APPLICATION NO.	FILING DATE	FIRST NAMED INVENTOR	ATTORNEY DOCKET NO.	CONFIRMATION NO.
09/818,290	03/27/2001	John A. Corey	21535-006	9240

Office Action Summary

DETAILED ACTION

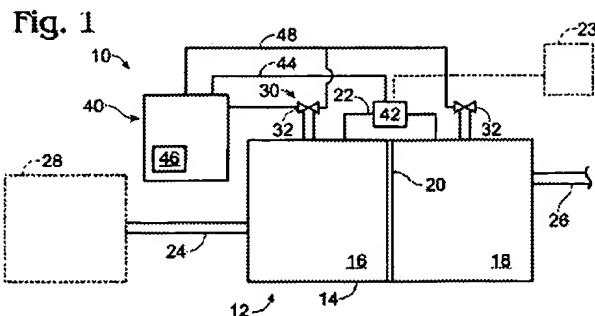
With respect to Claim 1, Herron discloses a fuel cell system that is provided with an anode chamber supplied with fuel, a cathode chamber supplied with oxidant, an electrolytic membrane separating the two chambers and a series of conduits that connects the anode and cathode chambers wherein two valves are disposed along the conduits for the purposes of governing fluid supply (see Figure 1 of this reference, shown below).
